ARCHITECTURAL REVIEW BOARD STAFF REPORT

Project #/Name	ARB-2020-129: Scruby Property – Verizon Tier 3 PWSF
Review Type	Advisory Review
Parcel Identification	05400-00-00-072A0
Location	East side of Greenwood Station Road, just south of I-64 (See Figure 1.)
Zoned	Rural Area (RA) / Entrance Corridor (EC)
Owner/Applicant	Brian Gray Scruby / GDN Sites (Nathan Holland) / Verizon Wireless
Magisterial District	White Hall
Proposal	To construct a telecommunications facility consisting of a 94' monopole tower and associated structures and equipment.
Context	The immediate area is wooded and adjacent to Interstate 64. The surrounding area is rural in character with residential and agricultural buildings, many of which are historic.
Visibility	See page 4.
ARB Meeting Date	February 1, 2021
Staff Contact	Margaret Maliszewski and Khris Taggart

Figure 3: The monopole site is highlighted in yellow. The red lines represent the distance along the I64 Entrance Corridor that the balloon was visible.

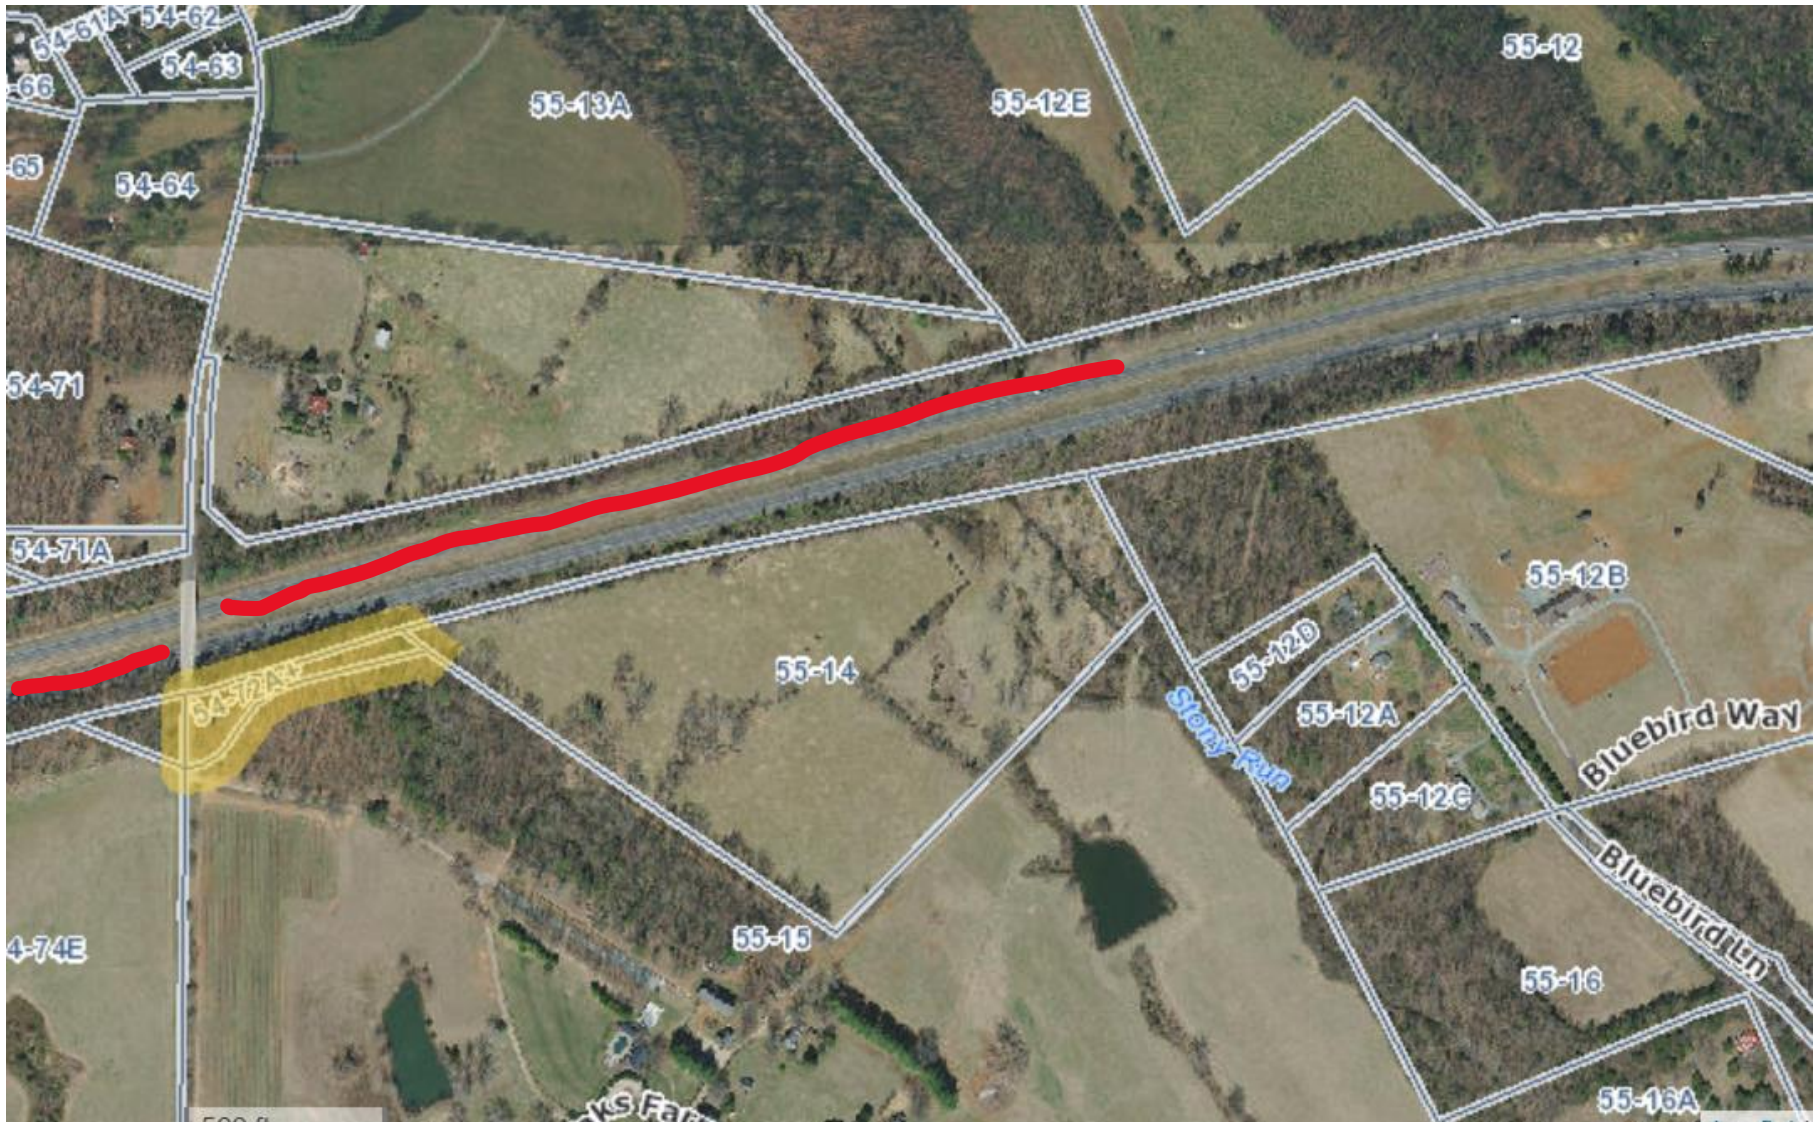
East of the site, travelling westbound on I-64, the balloon was visible from the I-64 EC for approximately 2300'. West of the site, travelling eastbound, the balloon was visible only for a short distance close to Greenwood Station Road.

When visible along I-64, the balloon was seen within or behind trees. The balloon appeared near the tops of some trees, but it was not skylit.
